REMARKS

This paper responds to the Office Action of January 10, 2005 in which the Examiner commented on inventorship and priority, objected to the drawings and suggested a clarification in claims 8 and 9. The Examiner rejected all the claims under 35 U.S.C. § 103 as unpatentable in view of combinations of Berman, Wortrich et al., Schultz et al. '259 and '316, and Sancoff et al.

Fig. 13

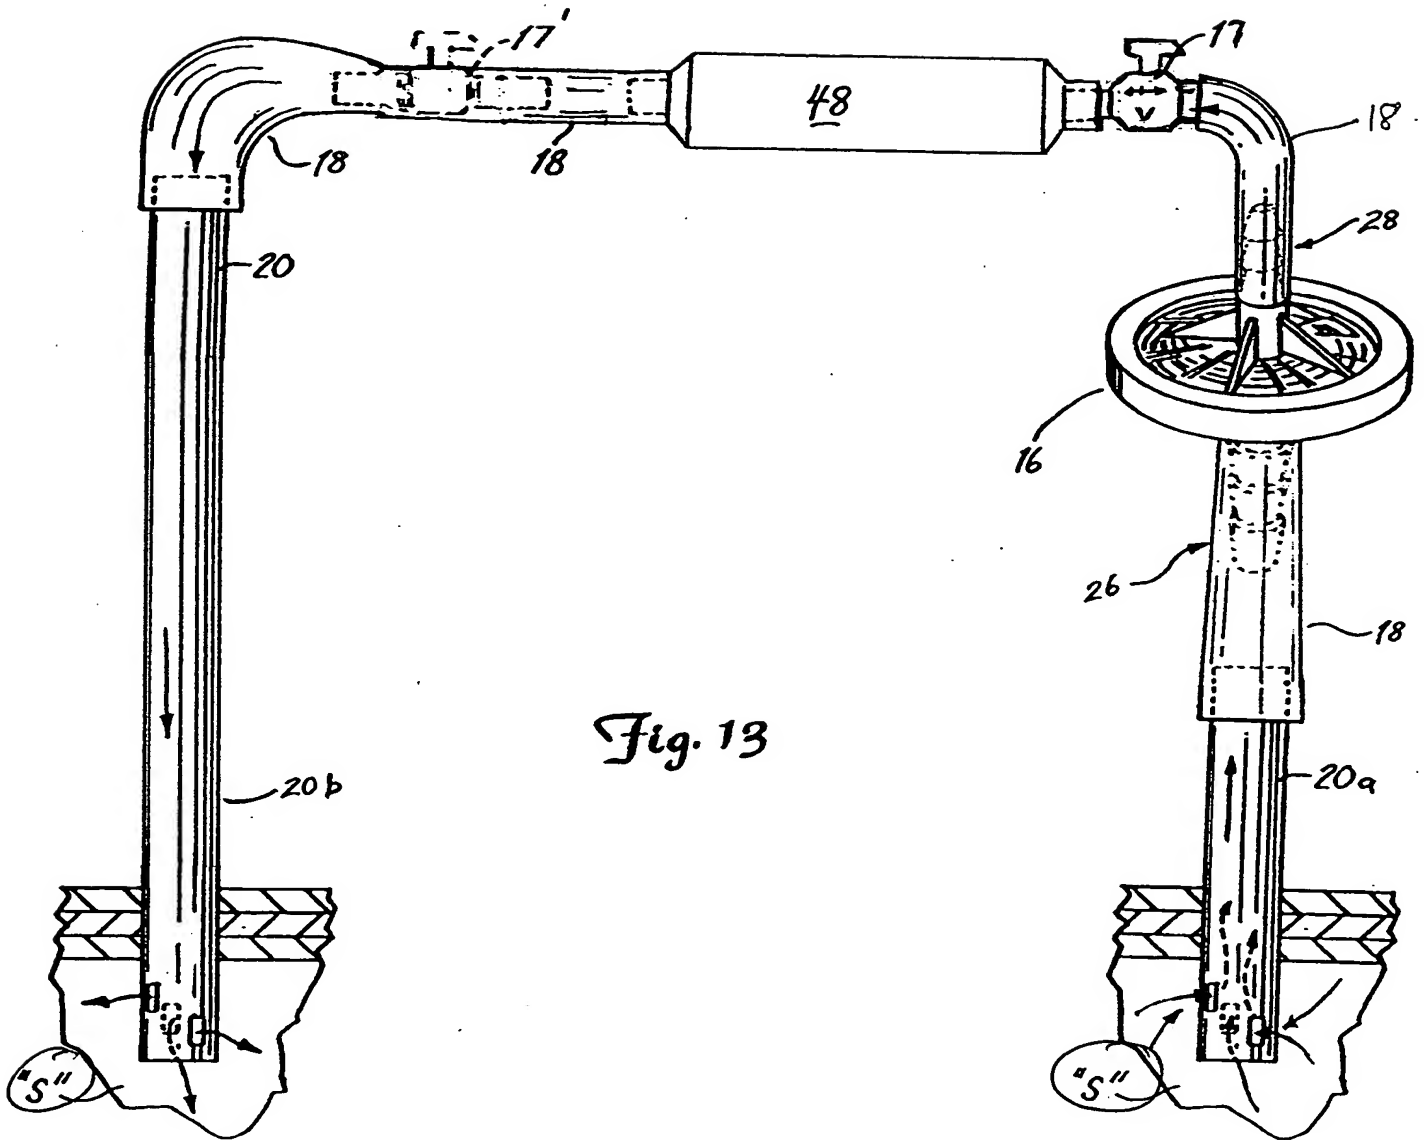
The attached annotated drawing sheet shows changes in Fig. 13. In Figure 13, character "S" has been changed in accordance with the Examiner's comments, i.e., the quotation marks have been deleted. A replacement sheet reflecting the changes is also attached.
